UNITED STATES PATENT AND TRADEMARK OFFICE

APPLICATION NO.	FILING DATE	FIRST NAMED INVENTOR	ATTORNEY DOCKET NO.	CONFIRMATION NO.
10/723,216	11/26/2003	Takehisa Takoshima	02008.134001	2554

Office Action Summary

DETAILED ACTION

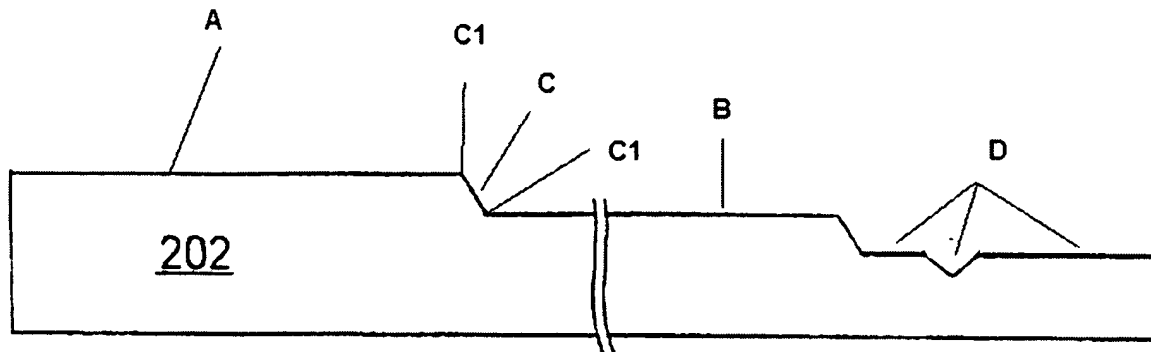
- Preparing a probe pin forming substrate (202 in Figs. 2A-2J and the figure below) for forming a plurality of probe pins, as per claim 1 (see Figs. 5 and 6. see section "Probe Applications", pp. 36-38), by forming a probe pin groove part (see Figs. 2A-2J; see region comprising portions B, C, and D in the figure below) having a bottom surface (B below) substantially parallel to a surface (A below) of said probe pin forming substrate and an

inclined surface (C below) having a first end (C1 below) extending from said bottom surface (B) and forming an angle with the bottom surface (B) and a second end (C2 below) extending from said surface (A below) of the probe pin forming substrate (202 below), as per claim 2; the protrusion forming groove part is formed using anisotropic etching (clearly, from Figs. 2A-2J, the etching is anisotropic; see section "Fabricating the Contact Structure", pp. 21-30, in particular ln. 4 on page 24), as per claim 3

- Forming an alloy layer (alloy layer 256 in Fig. 2H; see page 28, lns. 10-15) deposited from the bottom surface (B below) over the inclined surface (C below) and said surface (A below) of the probe pin forming substrate (202), as per claim 1; a protrusion forming groove part (D) is also formed at an area where the alloy layer is formed on the bottom surface, as per claim 4, and alloy is formed at said protrusion forming groove part (see Fig. 2H); a conductive layer may also be formed over the alloy layer, as per claims 5 and 10 (see conductive layers 254 and 252 in Fig. 2H)
